# Watertown/ Waterbury

Bunker Hill Road - Bunker Hill Avenue – Road Safety Audit

April 18, 2017

Figure 18 Short Term Recommendations

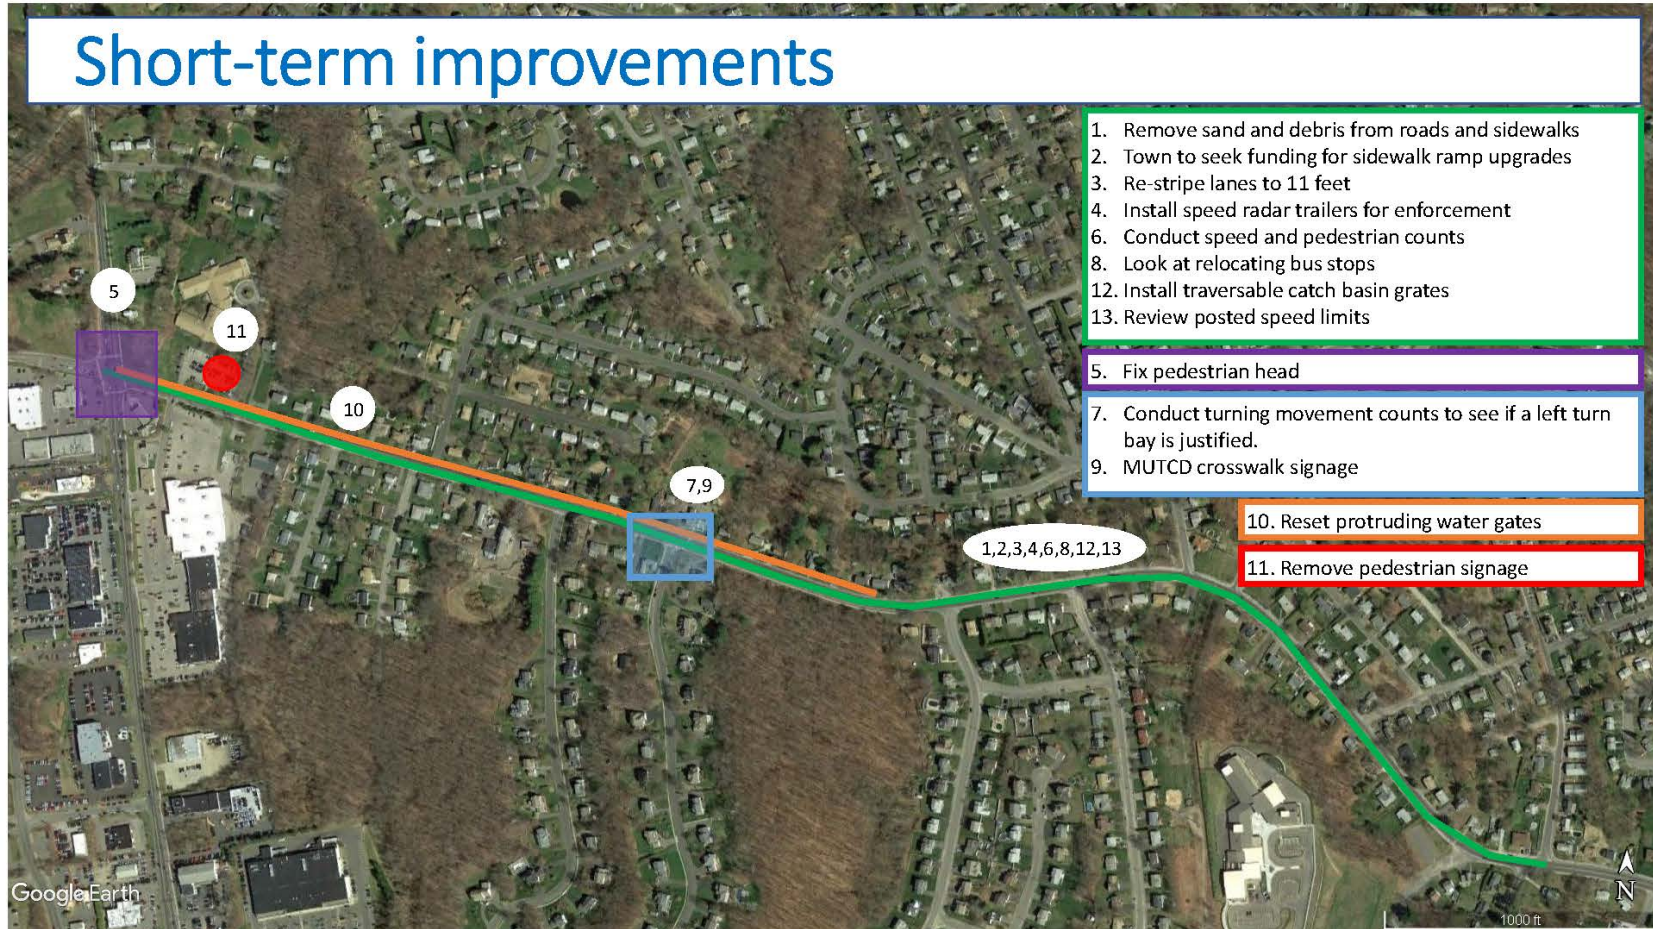
1. Town of Watertown and City of Waterbury to remove sand and debris from roads and sidewalks along corridor.
2. Town of Watertown to coordinate with CTDOT to determine status of LOTCIP funding for ramp upgrades along Bunker Hill Road (Figure 16).
3. Town and City to stripe shoulders and narrow travel lanes to 11' in both directions to channelize traffic and provide visual cues to motorists and vulnerable users.
4. City of Waterbury and Town of Watertown to collaborate with law enforcement to install speed radar trailers at strategic locations throughout corridor, to enforce current posted speed.

5. Town of Watertown to coordinate with CTDOT District office to fix the pedestrian head at the Straits Turnpike and Bunker Hill Road intersection.
6. The Town of Watertown and City of Waterbury to coordinate with COG to conduct speed and pedestrian counts along the corridor.

7. The Town of Watertown to conduct turning moving counts to determine if the left turn bay is justified at the Bunker Hill Road and Georgetown Drive intersection.

9. Town to replace outdated pedestrian signs and install MUTCD compliant advanced crosswalk signage with distance indicator and down arrows for the Bunker Hill Road crosswalk in front of Pleasant View Manor (Figure 17).

10. Town to reset the protruding water gate along the sidewalk in Watertown section of Bunker Hill Road.
11. Town of Watertown to remove pedestrian crossing sign at the Apple Rehab building, westbound.

12. Town and City to replace all catch basin with traversable grates with bike compatible grates.
13. Town of Watertown to coordinate with CTDOT Office of the State Traffic Administration, as the segment of Bunker Hill Road between Route 63 and the Waterbury Town Line listed as a 30 mph zone with a posted speed of 25mph. The speed limit signage should be changed to reflect this fact.

Figure 20 Mid Term Recommendations

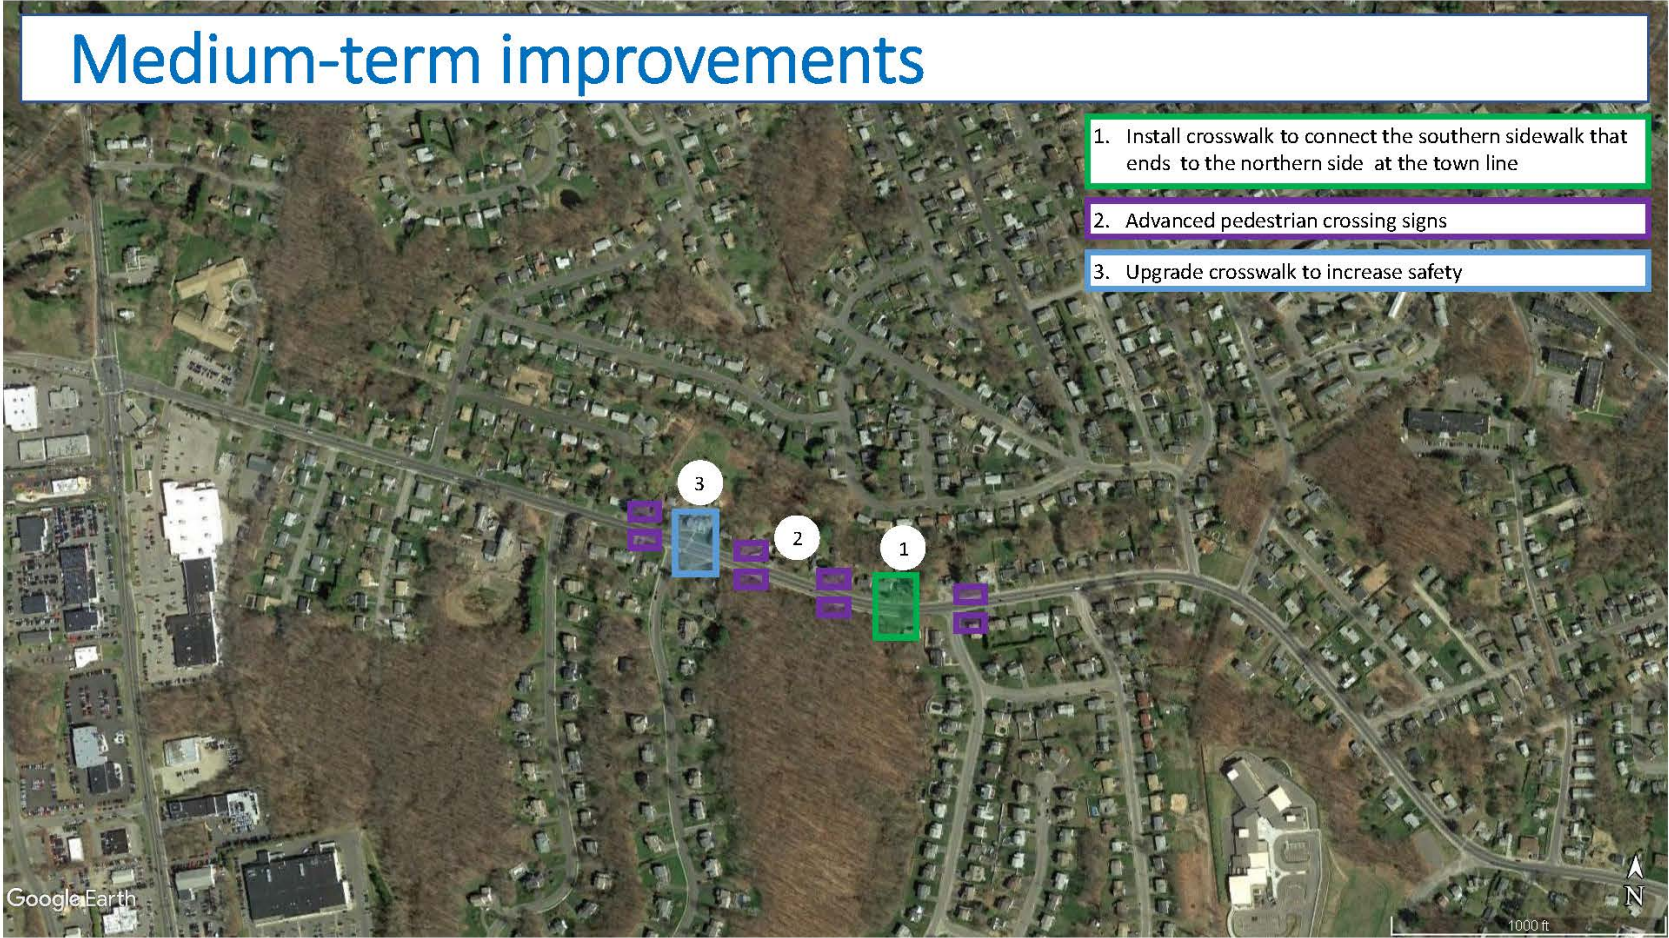
1. Town to install a crosswalk to link the sidewalks along Bunker Hill Road and Bunker Hill Ave at current town line where sidewalks terminate and consider installing rectangular flashing pedestrian beacons at this crossing.
2. Town to determine if advanced pedestrian crossing warning signs with flashing beacons are warranted at this crossing.
3. Town to consider upgrading the crosswalk at Pleasant View Manor with the following safety features if warranted:
  - a. texturized materials;
  - b. raised crosswalk;
  - c. bump outs to narrow crossing (Figure 19); and
  - d. installing a hybrid pedestrian beacon signal.

Figure 21 Long Term Recommendations

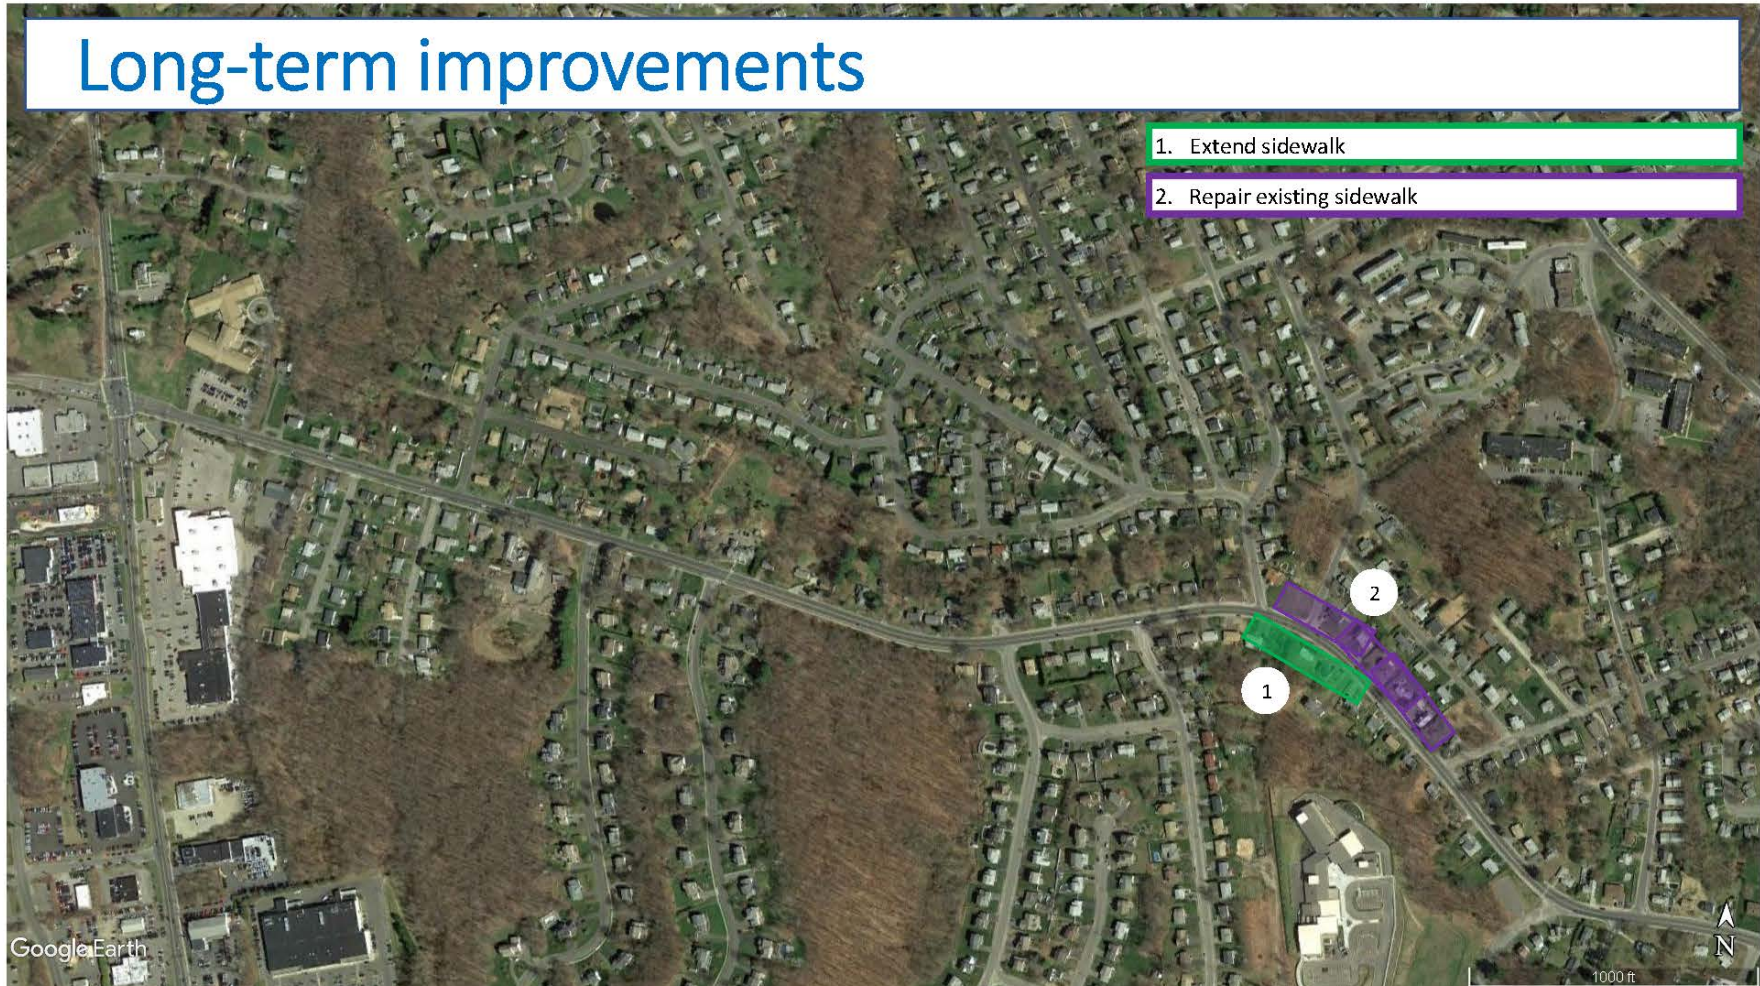
1. Town to extend sidewalk along Bunker Hill Road east across Waterbury town line to connect to sidewalk at Genoa Avenue.
2. City to fix deteriorated sidewalk along Bunker Hill Ave in the City of Waterbury
